RE: DA-84/2016

Heritage Advisor to Liverpool City council

21 Atkinson Street, Liverpool

Visible from the context of the heritage item are the south and east elevations of proposed buildings 8 & 9.

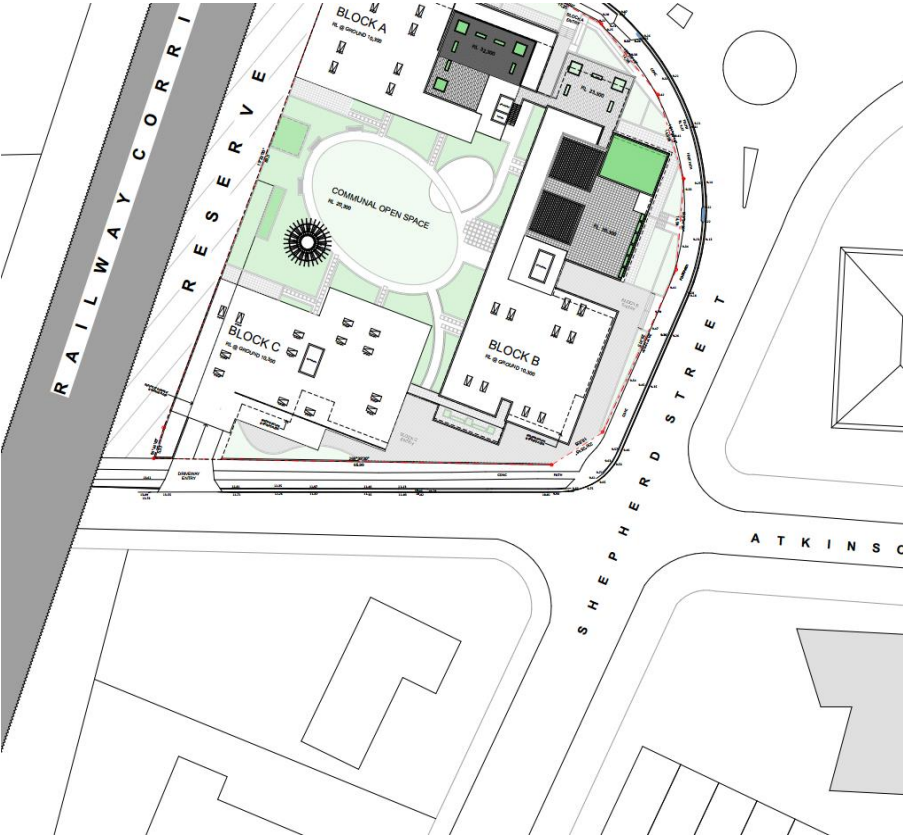
The document indicates that four shops will address the corner of Shepherd and Atkinson Streets and hence face the heritage site. The southern elevation at ground level includes a community space and gym. There are no detailed drawings provided to indicate the scale, materials and details of these two prominent elevations.

- *How is the impact of the new development on the heritage significance of the item or area to be minimised?*
 - *There are no elements on the two primary elevations of the proposal which interpret or reference the scale, form, materials or details of the listed building*

- *Is the new development sympathetic to the heritage item? In what way (e.g. form, siting, proportions, design)?*
 - *There are no details or formal references to the industrial architecture evident in the proposal. There is a reference to the use of Gertrudis brown brick in retaining walls and an orange feature wall but no indication as to why this could be an appropriate reference to a single storey red brick mill building.*

- *Will the additions visually dominate the heritage item? How has this been minimised?*
 - *While an argument may be mounted for the height given other planning matters, the large height differential would warrant mitigation. A direction for mitigation was offered during the Pre-DA discussion but does not appear to have been adopted*

- The orange feature colour is replaced with a wall clad in recycled brick to interpret the scale and impact of the traditional industrial buildings in the vicinity

The Landscape Plan at Street level also illustrating the ground floor built form and uses

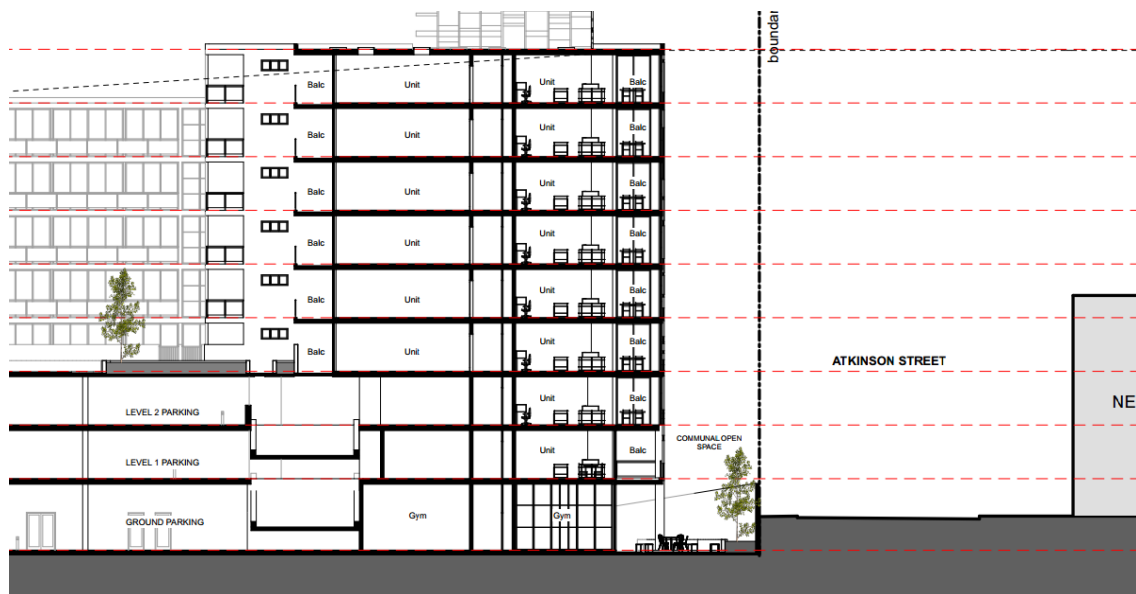
- *How does the new development affect views to, and from, the heritage item? What has been done to minimise negative effects?*
 - *There are no drawings provided of the ground level treatments which indicate how views along both streets would be enhanced by the built form or landscaping*

- *None of the proposed built forms adopt any orientation towards the listed building or at right-angles to the street alignments, a common form of referencing*

- The ground floor built forms on Atkinson Street are oriented towards the street alignment in order to address the traditional setbacks and orientations of industrial buildings

- The perimeter wall presented to Atkinson and Shepherd Streets be detailed in industrial off-form concrete with interpretive markings to reflect the industrial heritage of the local industries, in conjunction with the LHS
